# Memo

**Re:** Dove Landing Playground Safety Audit and Park Amenity Walk

City of Woodburn Certified Playground Safety Inspector (CPSI) Jeff Crabtree conducted the playground safety audit of the play structures and surfacing at Dove Landing on **1/11/24**.

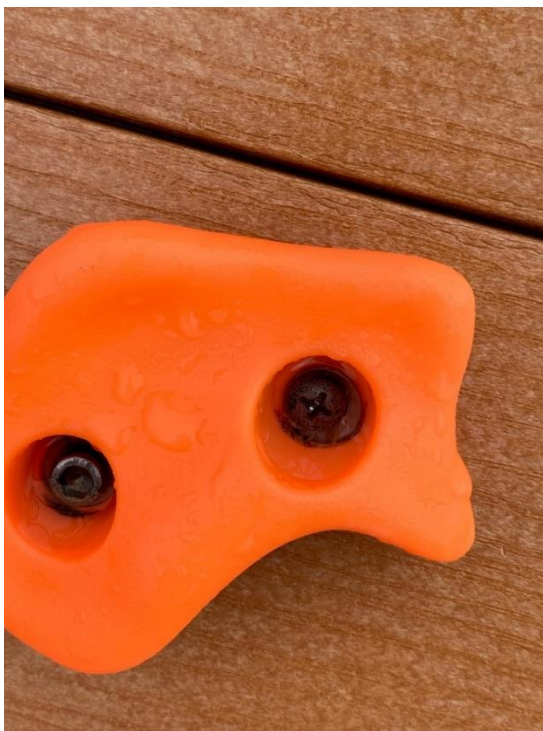
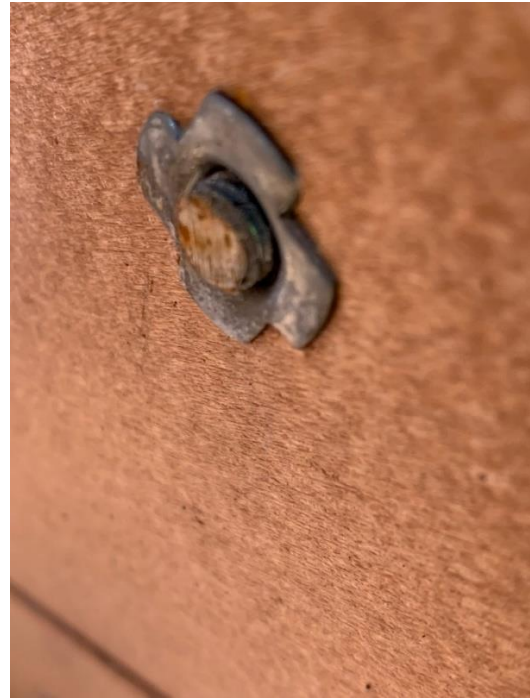
- **3 head entrapment hazards were identified. (view video links below)**
  - The top and bottom opening built into the Tic Tac Toe activity wall has gaps in it that allow the torso probe to pass but not the head probe.
  - A barrier wall opposite the activity wall also has a gap between the bottom of the barrier wall and the play platform. Again, the torso probe fits through, but the head probe does not. If the torso fits, then the head probe must fit as well.
